Plug and Abandonment Procedure
for
DJR Operating, LLC
Jicarilla 362 B 1
API # 30-039-23491
NE/NE, Unit A, Sec. 7, T23N, R4W
Rio Arriba County, NM

Attachment to notice of Intention to Abandon

Well: Jicarilla B 1

BLM - FFO - Geologic Report**Date Completed** 6/22/2022

Proposed Wellbore Diagram
DJR Operating, LLC
Jicarilla 362 B 1
API # 30-039-23491
NE/NE, Unit A, Sec 7, T23N, R4W
Rio Arriba County, NM

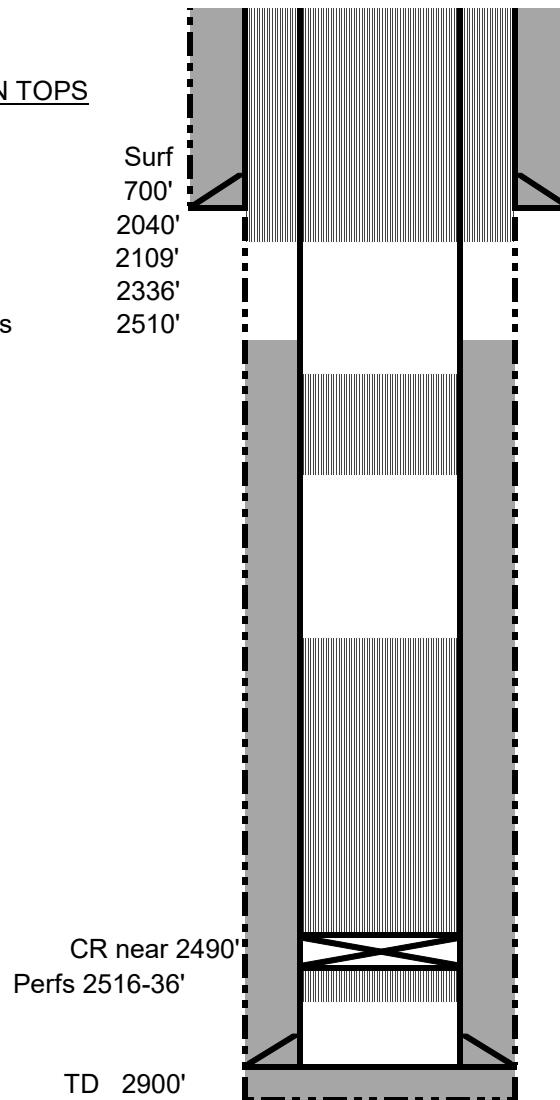
1. Plugging operations authorized are subject to the attached "General Requirements for Permanent Abandonment of Wells on Federal and Indian Lease."
2. The following modifications to your plugging program are to be made:
 - a. Extend Plug 2 to 1890' to account for required excess.
 - b. Extend Plug 3 to 605' to account for required excess.
3. Farmington Office is to be notified at least 24 hours before the plugging operations commence at (505) 564-7750.

-Extend Plug 2 to 1890' to account for required excess.

-Extend Plug 3 to 605' to account for required excess.

Plug 3: Nacimiento top: Spot balanced plug from 750' to 650'.

Plug 2: Pictured Cliffs, Fruitland, Kirtland, and Ojo Alamo tops: Spot blind plug from top of CR to 1990'.
